APPLICATION NO.	FILING DATE	FIRST NAMED INVENTOR	ATTORNEY DOCKET NO.	CONFIRMATION NO.
10/519,694	10/13/2005	Thomas Gschwind	240102.402USPC	6923

Office Action Summary

DETAILED ACTION

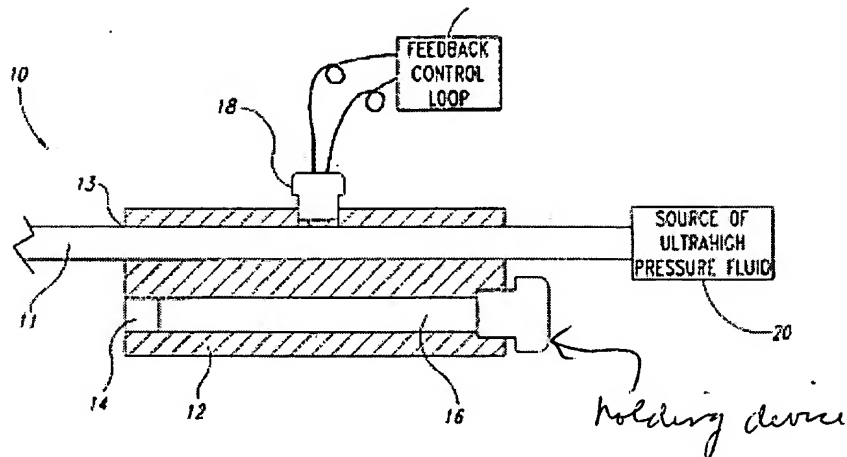
Raghavan et al teach that it is old in the art to provide a holding device, adapted to couple the heating element to the fluid line. See the Figure shown on next page:

It would have been obvious to one having ordinary skill in the art to modify Wu by providing a holding device, adapted to couple the heating element to the fluid line, in order to firmly secure the heating device to the fluid line. Raghavan et al is silent as to whether or not the holder is formed of an electrically insulating material. However, it would have been within the purview of one having ordinary skill in the art to form the holder of an electrically insulating material, since it has been held to be within the general skill of a worker in the art to select a known material on the basis of its suitability for the intended use as a matter of obvious design choice. *In re Leshin*, 125 USPQ 416.
